**SERVICE BULLETIN**

**APPLICABILITY:** 2019-22MY Ascent

**NUMBER:** 07-219-23R

**SUBJECT:** Genuine Alternative Battery Replacement

Remaining Height Is Less Than 2mm

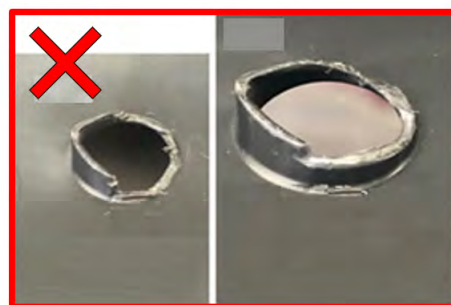
- A. CAREFULLY** cut off and trim the two protrusions on the bottom of the battery tray. This will allow a more streamlined fit when installed on the vehicle. Try to make the cut as flush as possible.

**CAUTION:** Be sure the protrusions are trimmed flush. The remaining protrusion height **MUST** be less than 2mm to provide proper fitment.

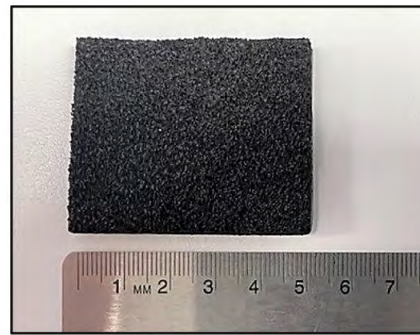
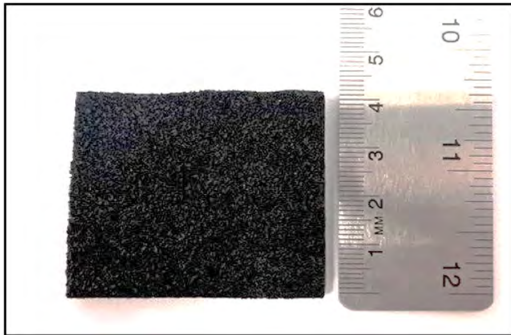
- B.** Remove the original battery tray. **DO NOT** discard, this must be returned to the customer.

- C.** Prepare two pieces of EPDM neoprene sponge strip. Cut the sections approximately 40 mm long and 50 mm wide. EPDM Neoprene SBR Strip (item # 6YHD7) supplied by Grainger® was used in the example photos below.

- D.** Cover the newly made holes with the two previously prepared EPDM neoprene sponge strip pieces.

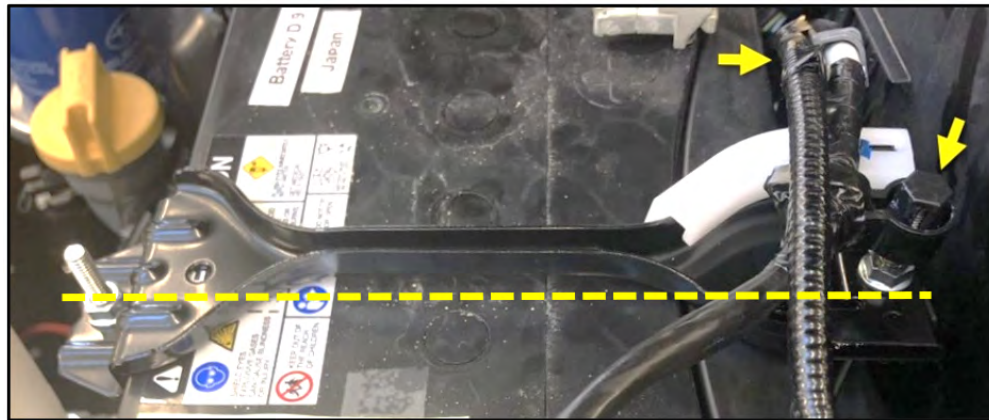
**STEP 5:** Assemble the **ORIGINAL** battery holder, **NEW** rear holding rod (p.n. 82161SJ000), and the **ORIGINAL** front holding rod as shown below. The original rod nut can be transferred to the new rear holding rod.

**NOTE:** DO NOT discard the original rear rod. This part is to be returned to be returned to the customer.
